To: CRA Board and Planning Board
Subject: Center Plaza Design Update
Date: August 5th, 2025

Plaza CRA/CDD Design Review Committee

CENTER PLAZA DESIGN UPDATE

Design Review Committee Discussion
August 19, 2025

Refined Play Area Design

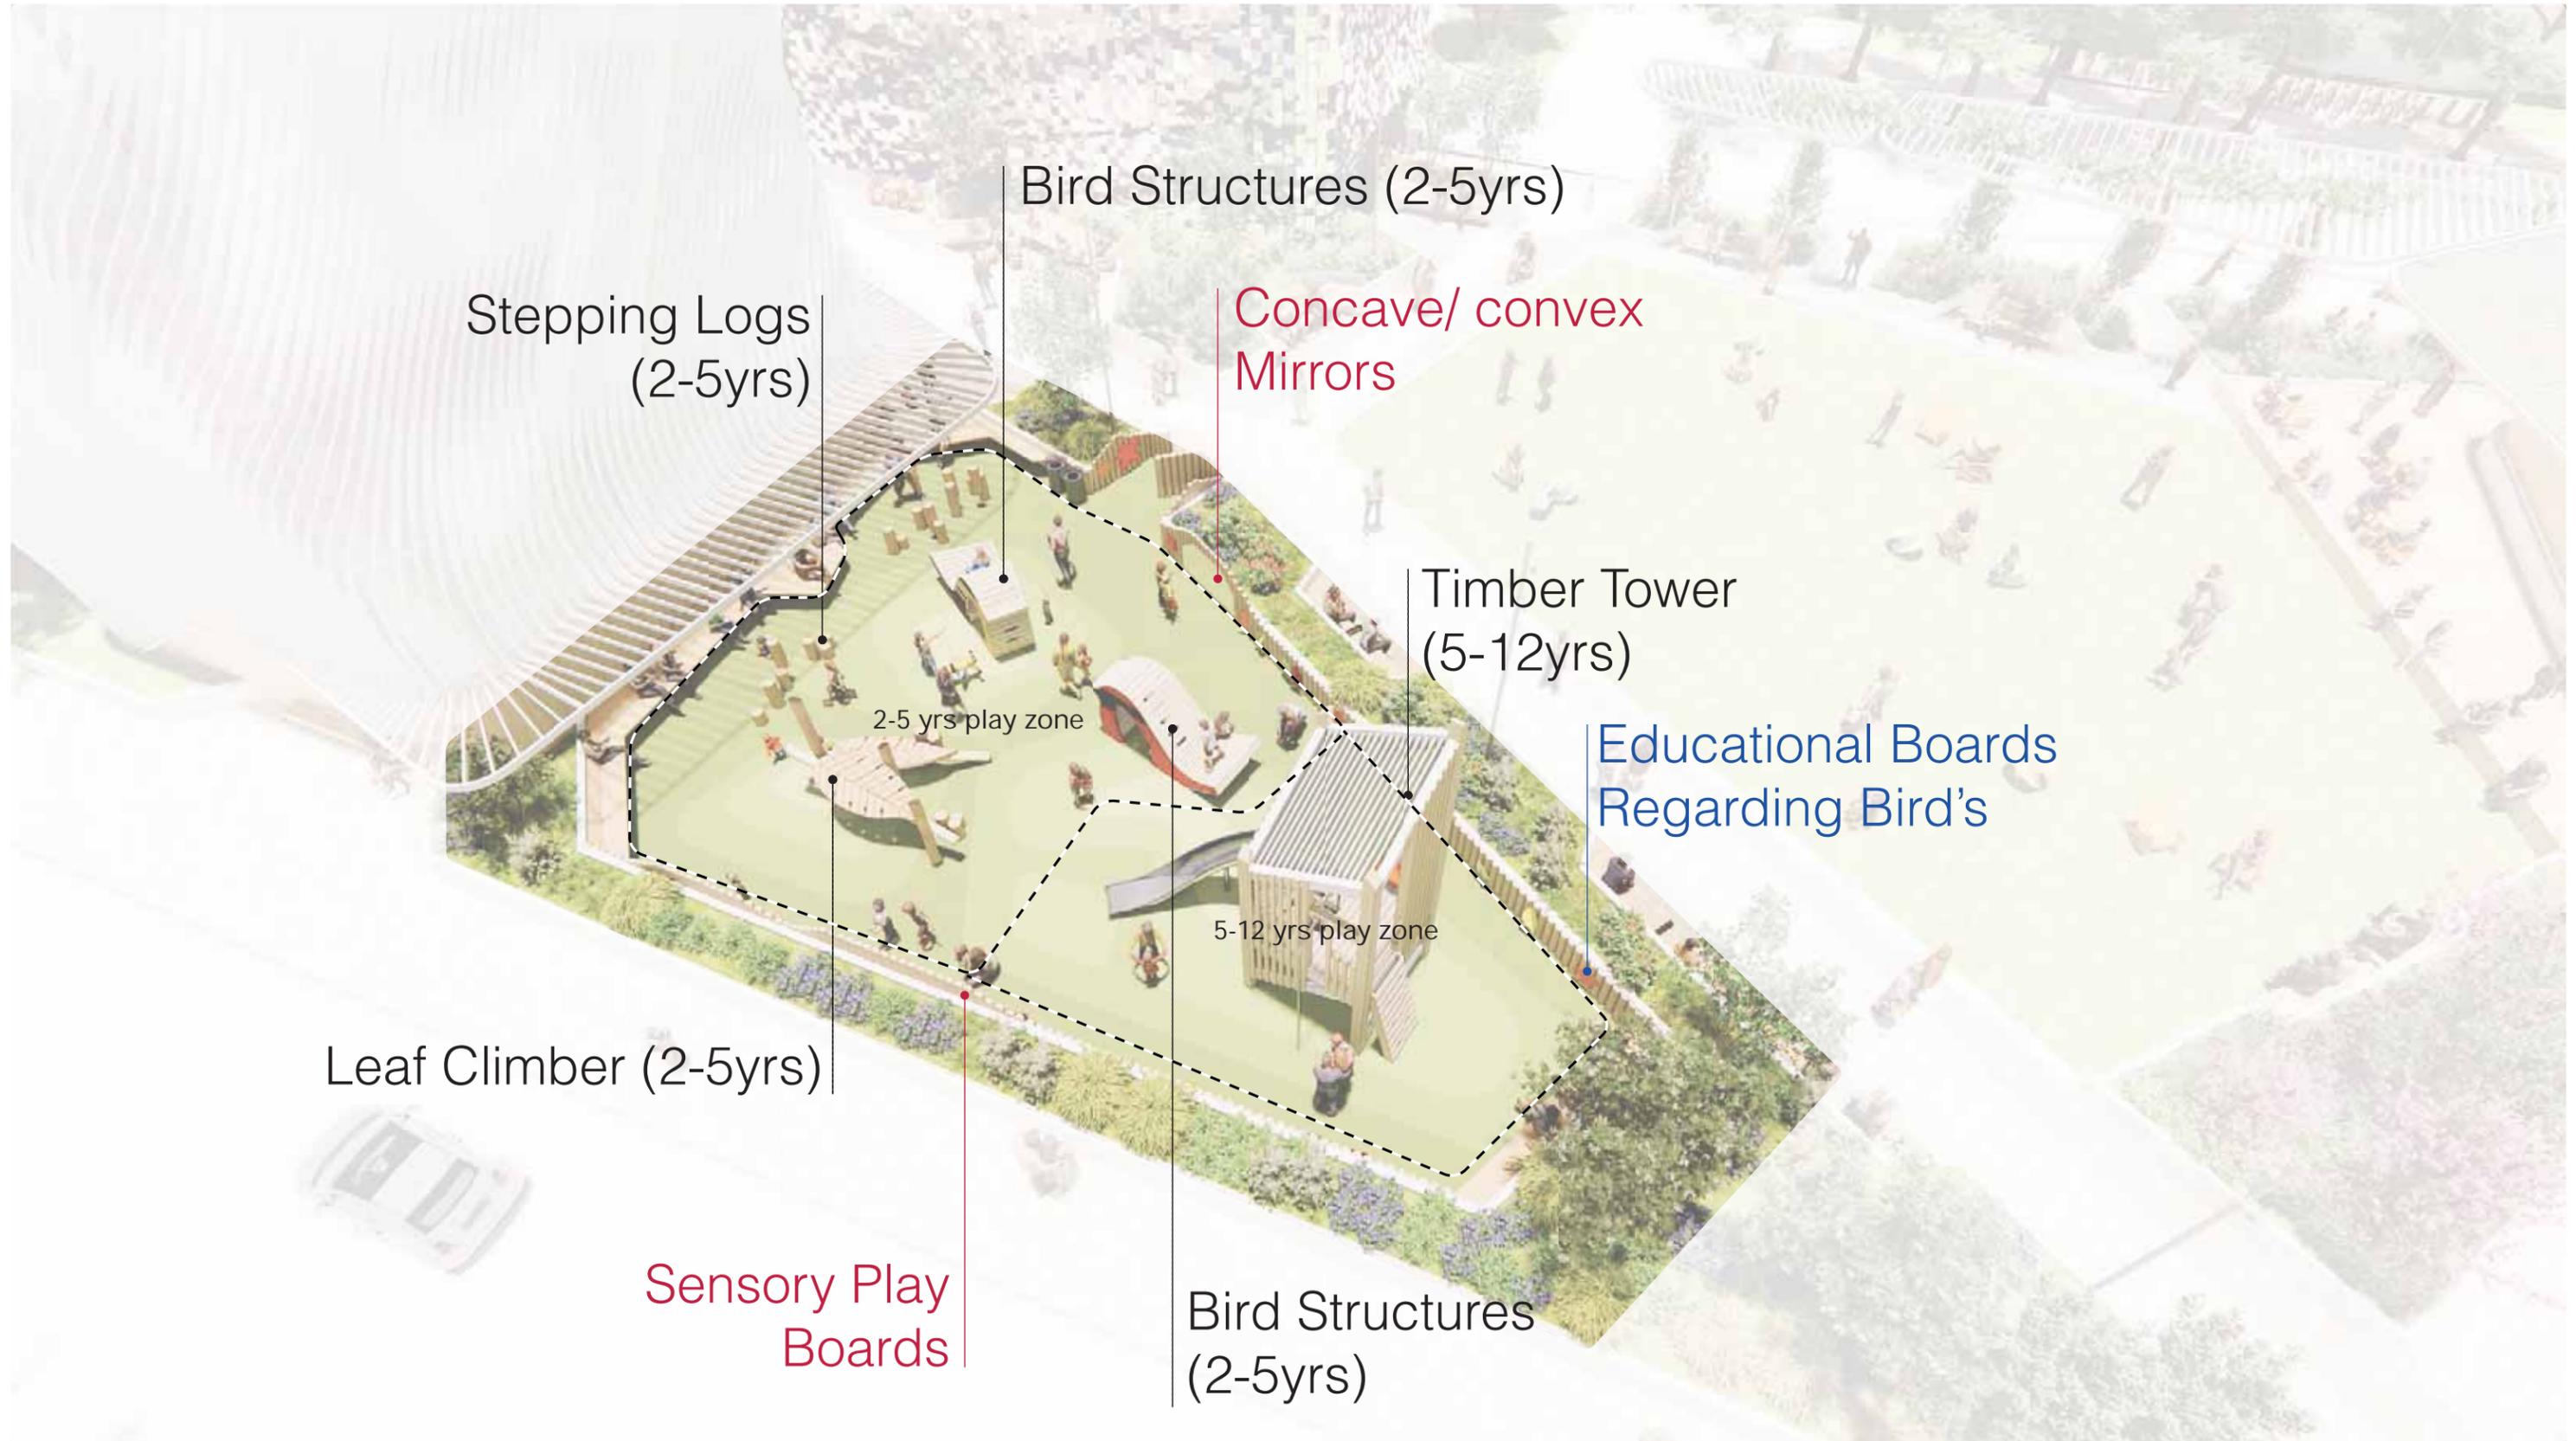
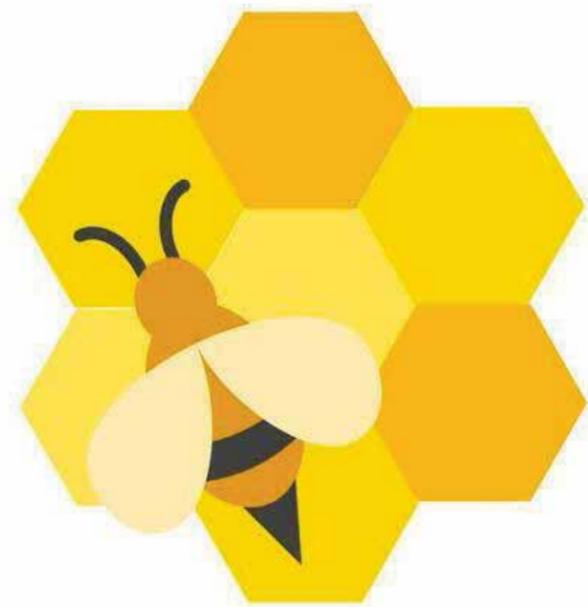
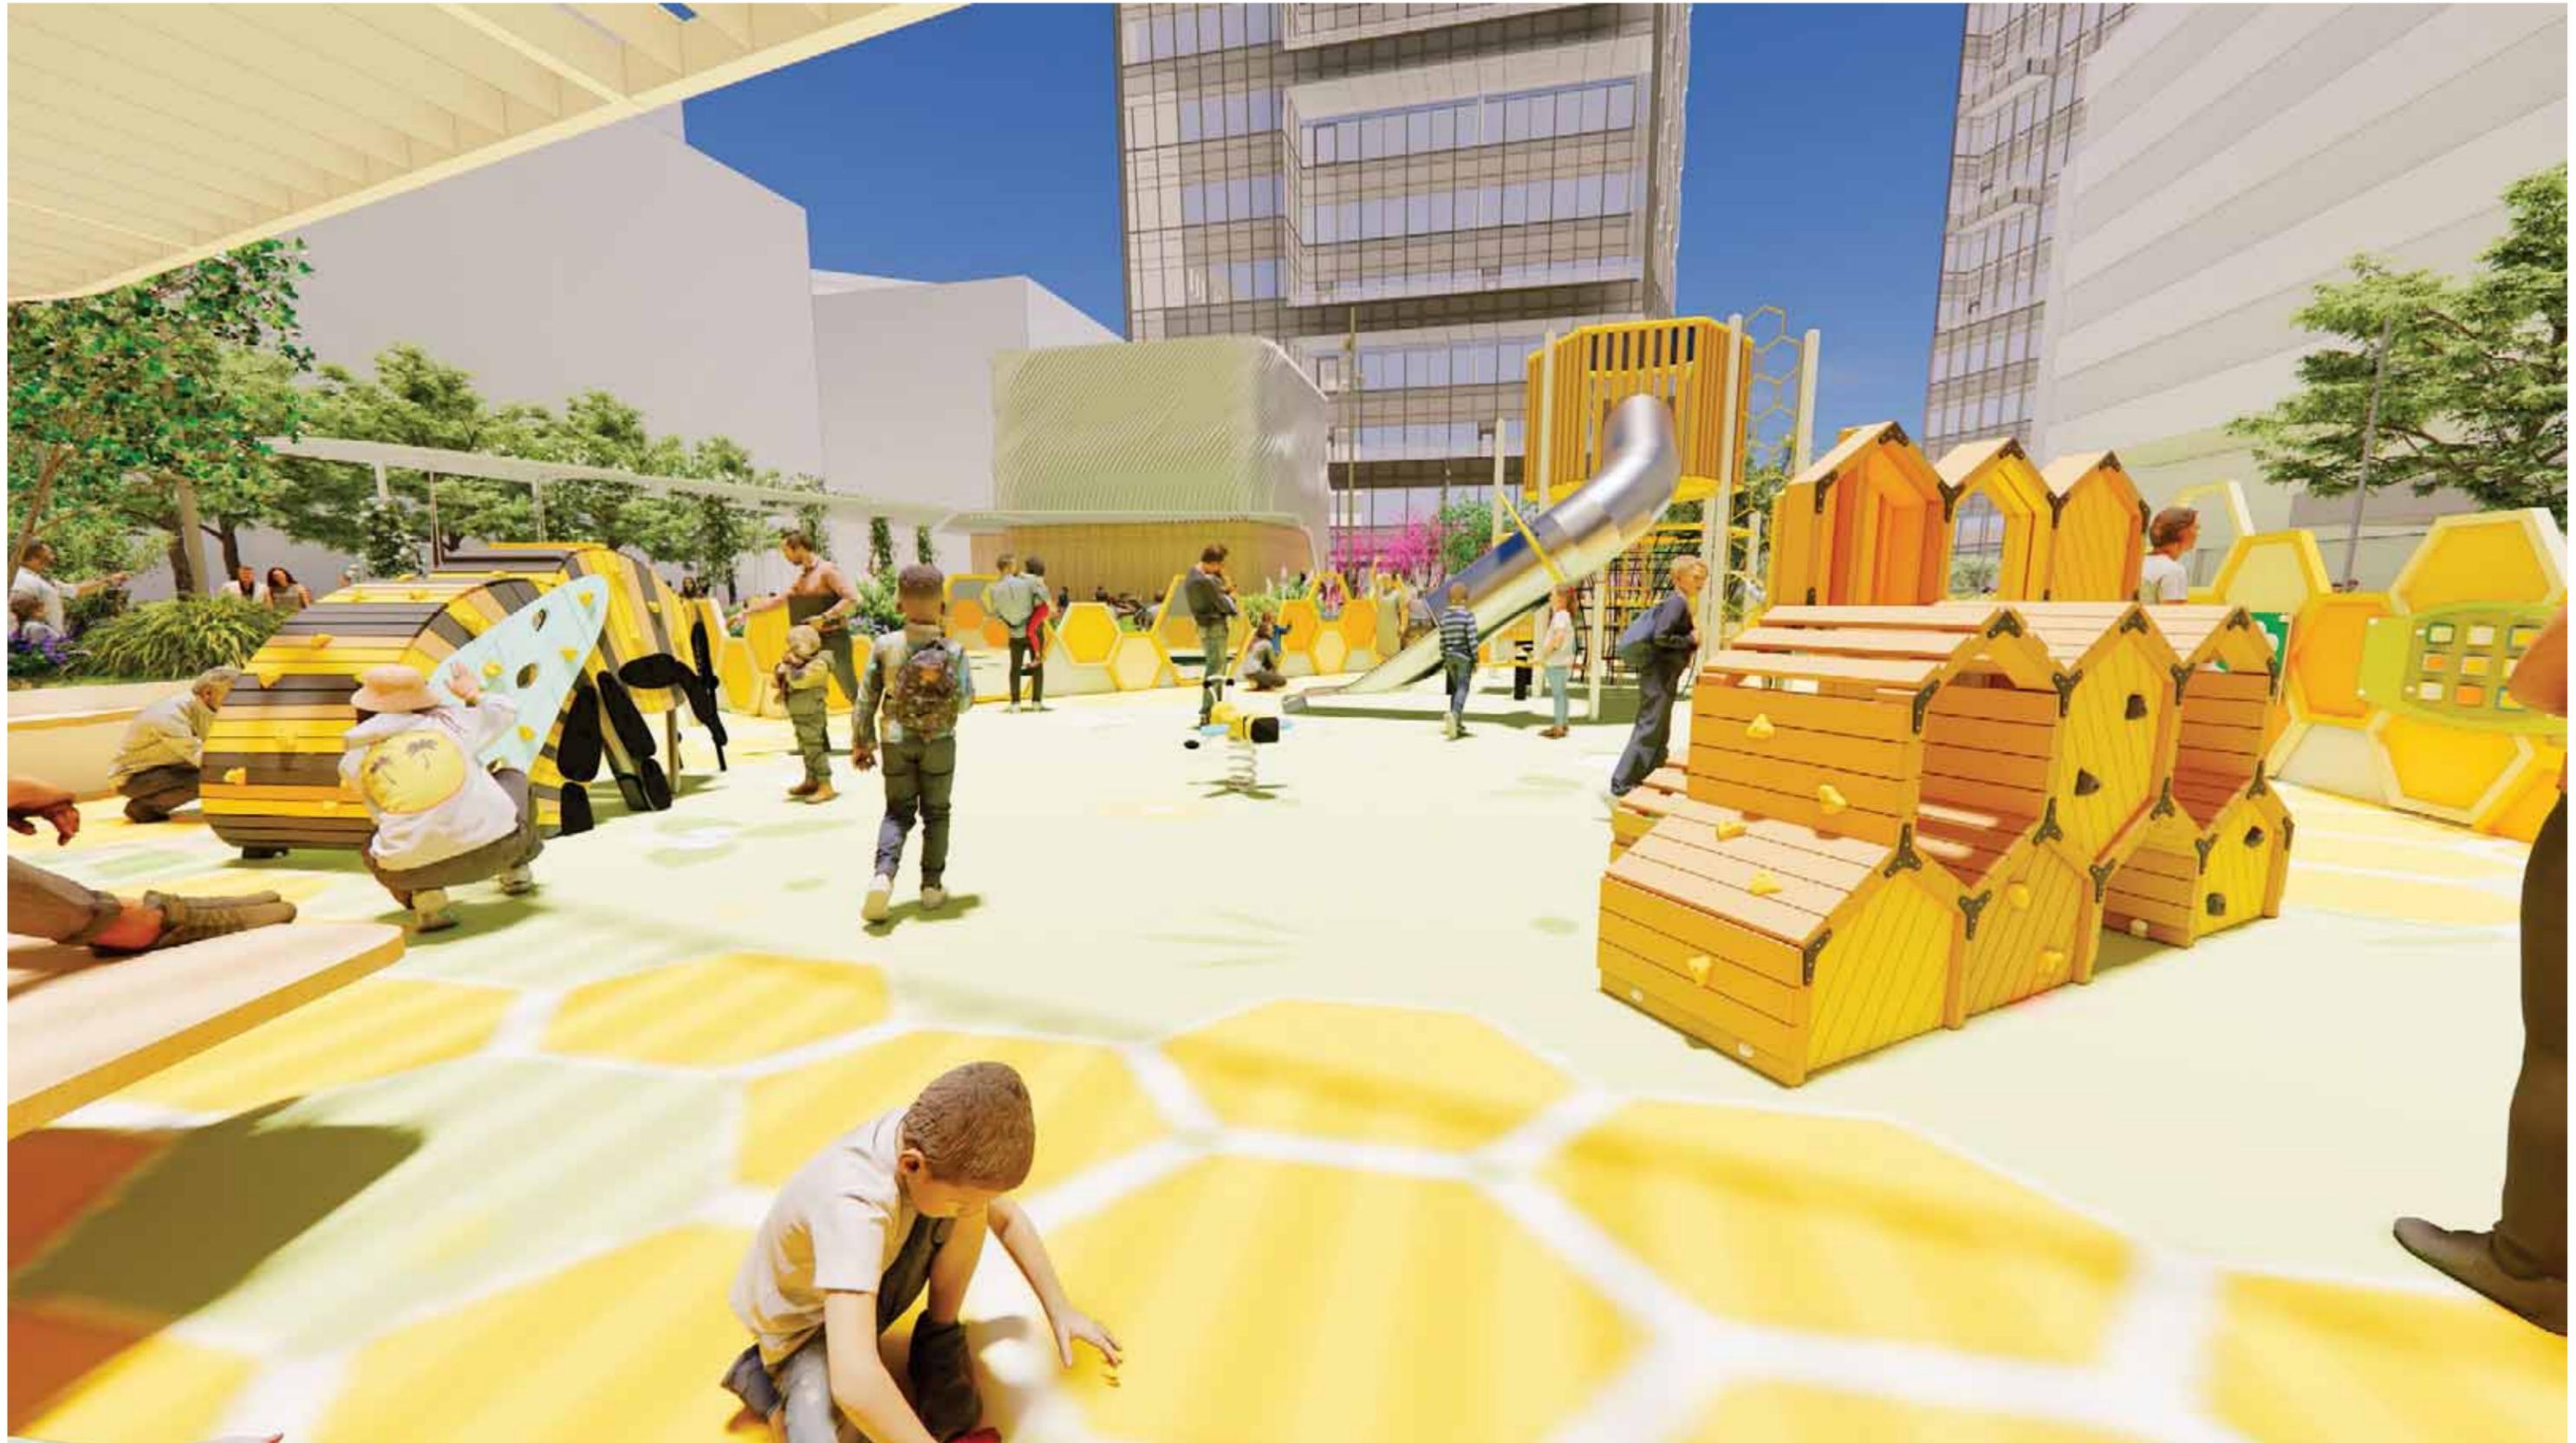
- Refine play structure material; mixed preference between wood and colorful structures, with a general preference to avoid rustic aesthetic.
- Enhance planting along play area edges.
- Increase variety and engagement, create a more immersive experience.
- Ensure adequate lighting and long-term durability.

Option 1 - The Bird's Nest

Option 2 - The Beehive
